January 14, 2022

RE: Response to Staff Comments Z-20-05
314-316 Batavia Place and 295-297 Albert Street
OUR FILE 15200D

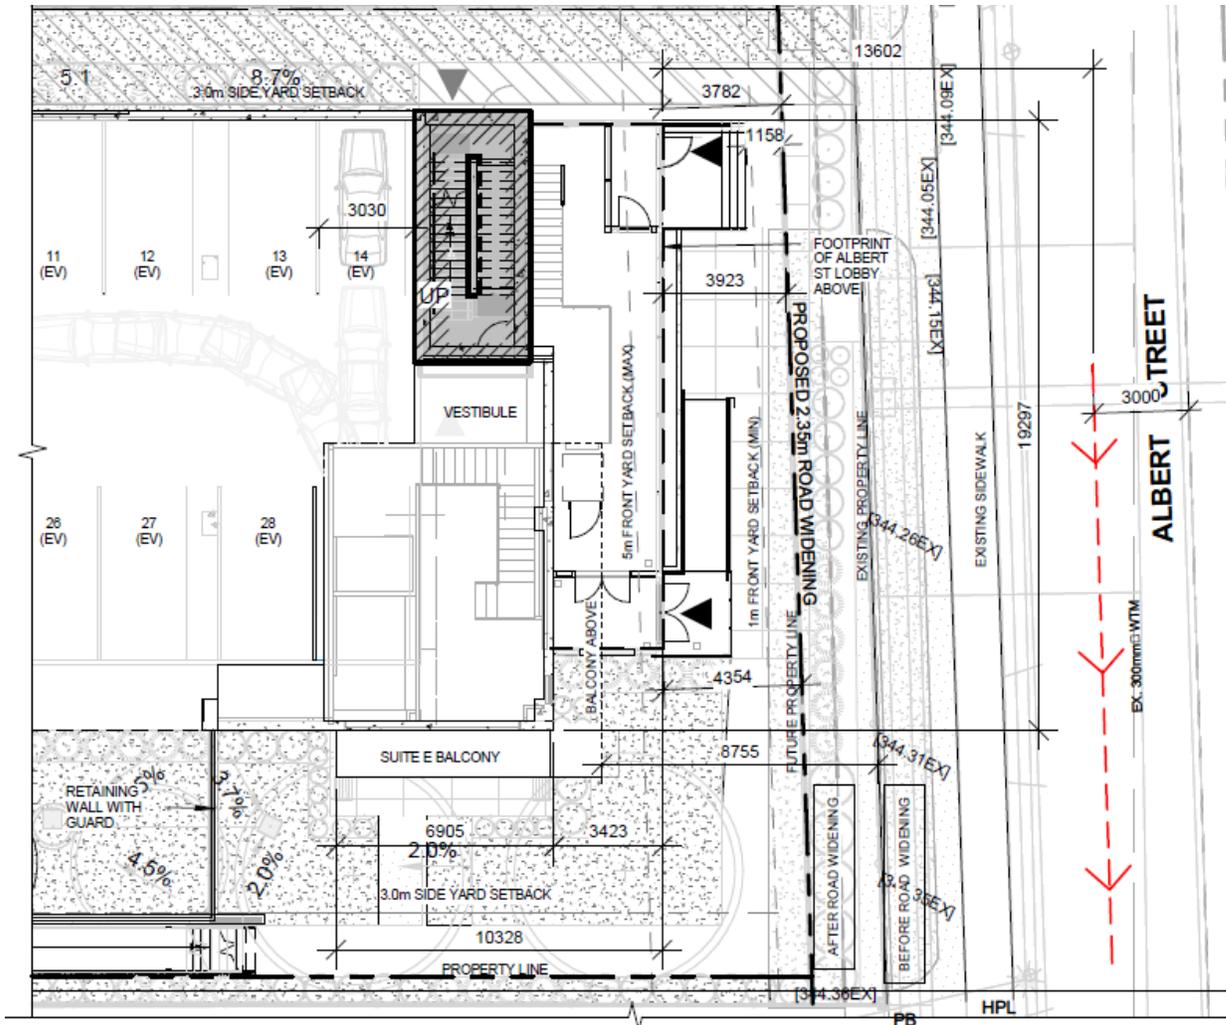
3. The building does not meet the maximum street line setback along Batavia Place. In next submission identify the maximum street line setback provided along Batavia Pl (north and south corners of building do not comply along Batavia Pl).

Street Line Setback – Batavia Place

The March 31, 2021 comments referred to specific requested changes to the Batavia portion of the building, to increase the habitable space at grade, including expanding the lobby/vestibule and including a transformer room. Both of those suggested changes were incorporated into the design.

The Zoning By-law does require a minimum percentage of the building façade to be located within a maximum street setback for Albert Street (which is a convertible frontage). No such requirement is included for a 'neighbourhood frontage' such as Batavia Place. We understand staff are interpreting

the By-law such that a higher test/requirement is afforded to a neighbourhood frontage compared to a convertible frontage. More specifically, that 100% of the building façade must be between 3 and 6 metres of Batavia Place, even though Albert Street only requires 75% and is “Mixed-Use Street” whereas Batavia Place is a “Residential Street.” We have reviewed the façade facing Batavia Place: the length of the entire façade is 26.537 m, while the length of the façade within 3-6 m of the Street Line is 15.165 m, representing 57% of the façade. The street line is curved due to the nature of the cul-de-sac street design. In our opinion, the building appropriately addresses the street, given its residential character and dead end street design for Batavia Place.
